APPEAL SUMMARY

Appeal ID: 26334	Project Address: 7206 SE 36th Ave
Hearing Date: 12/8/21	Appellant Name: Jeffrey T Parrish
Case No.: B-007	Appellant Phone: 5036797558
Appeal Type: Building	Plans Examiner/Inspector: David Hakimoglu
Project Type: residential	Stories: 1 Occupancy: R-5 Residential Construction Type: Wood Frame
Building/Business Name:	Fire Sprinklers: No
Appeal Involves: Alteration of an existing structure, occ Change from T to	LUR or Permit Application No.: 20-227000-RS
Plan Submitted Option: pdf [File 1] [File 2]	Proposed use: Basement ADU

APPEAL INFORMATION SHEET

PROPOSED STAIR SECTION

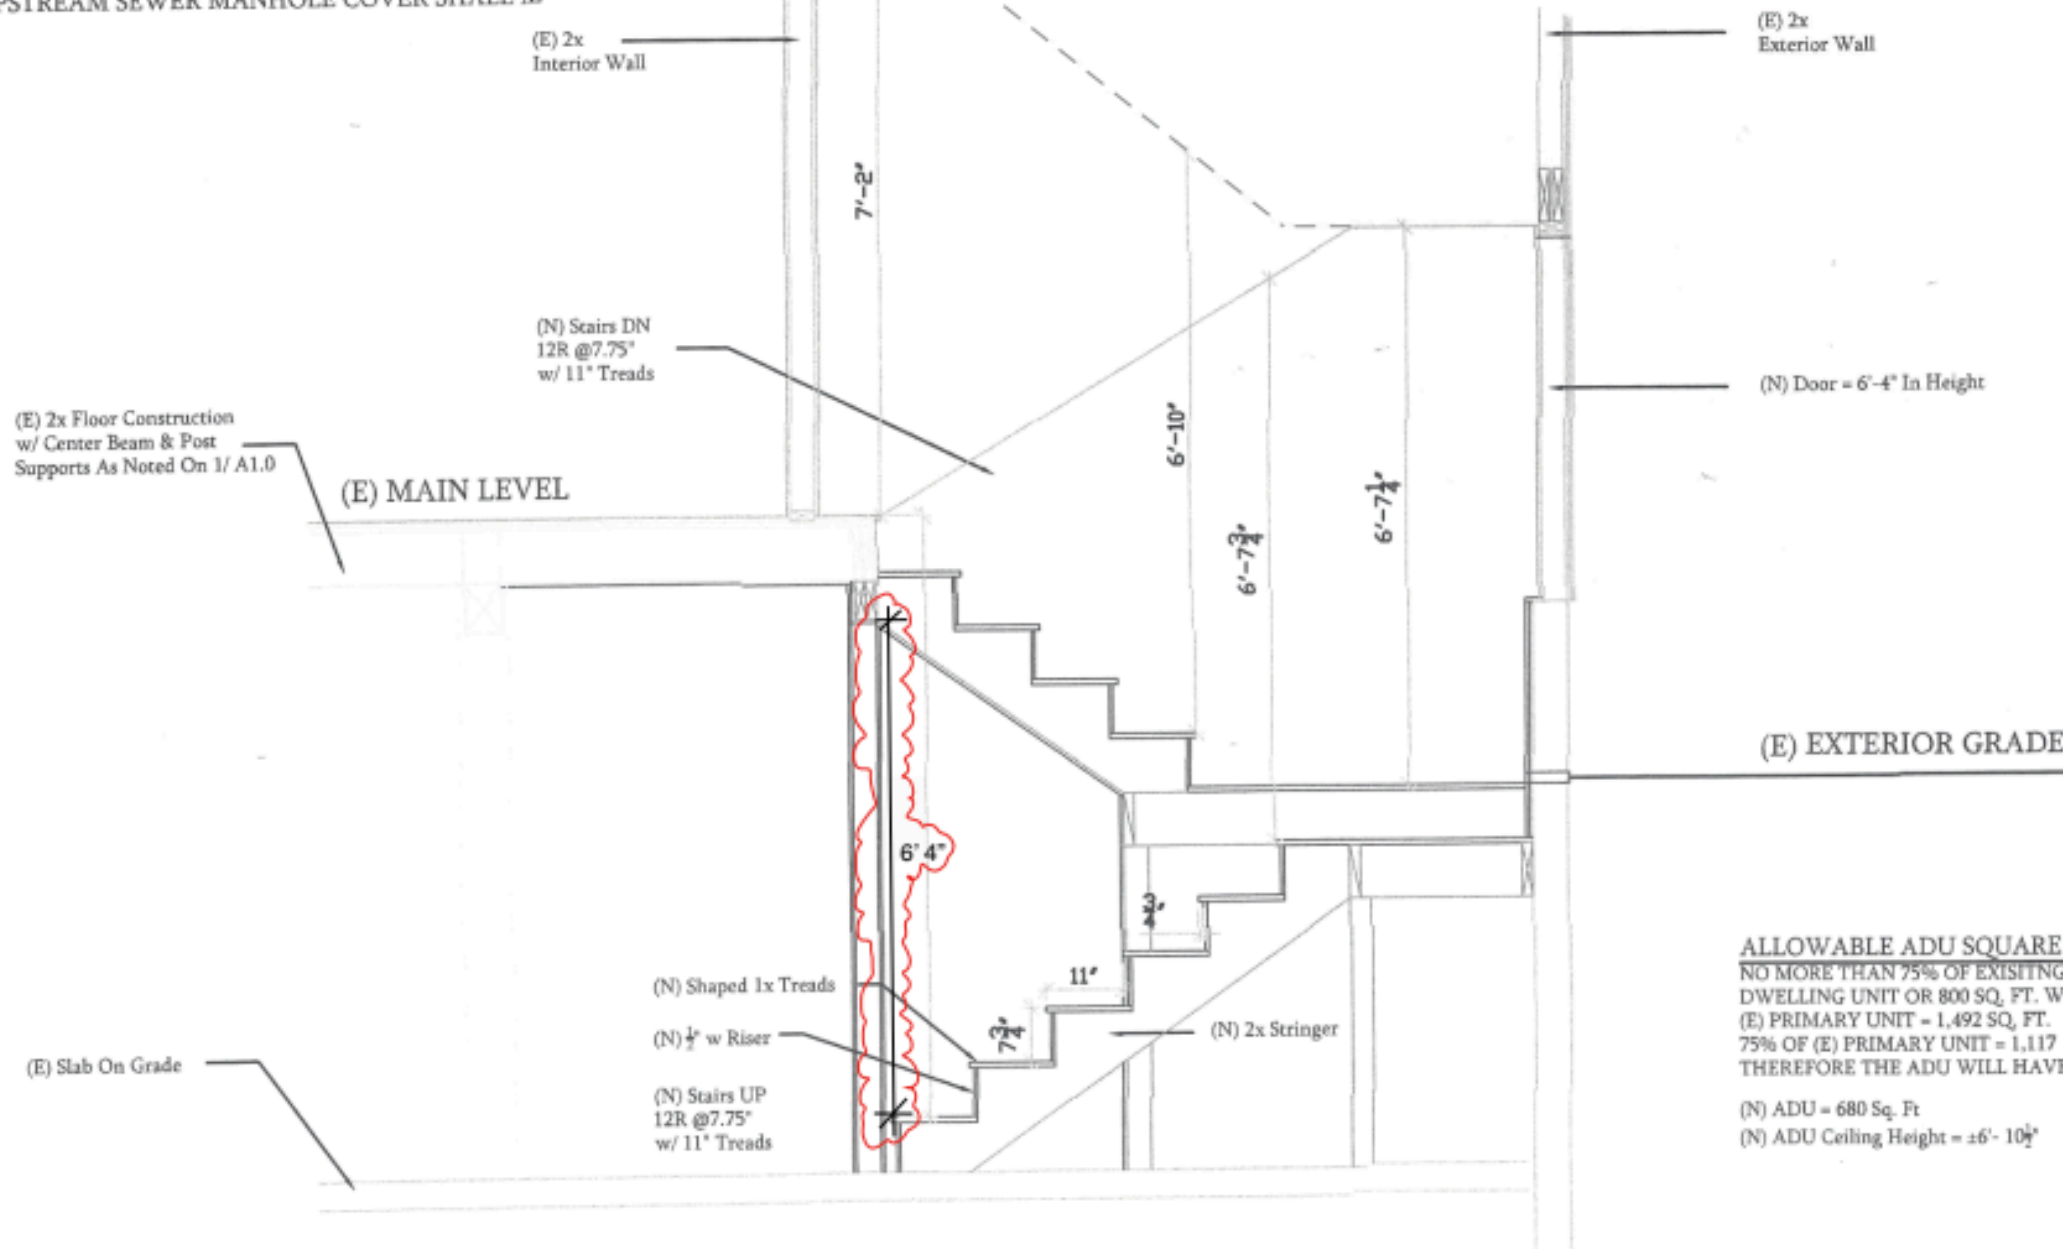
Code Modification or Alternate Requested Install 32"W by 76"H basement ADU egress door

Proposed Design Modify width and maximize height of existing opening to accommodate 32"x76" basement ADU egress door, as shown on original, approved plans.
Affix signage to warn of lower head height.

Reason for alternative Due to existing stair landing above existing door, maximum height only allows for 76" height door. Extremely extensive, cost-prohibitive modifications to roof and upper stairwell and/or exterior concrete walk way, foundation and sewer line prohibit a taller door.
Though an ADU, door will be within parameters of City of Portland exterior basement egress door for converted basements requirements.
Caution signage on both sides of door will warn of potential overhead clearance issues.

***Please note: Stairwell heights shown in provided approved plans section have been brought into compliance of 6'8" minimum height.

Basement ADU with reduction in the minimum required height of entry doors from 6 feet 8 inches to 6 feet 4 inches: Denied. Proposal does not provide equivalent Life Safety protection.
Appellant may contact Dave Tebeau (503-823-4072) with questions.
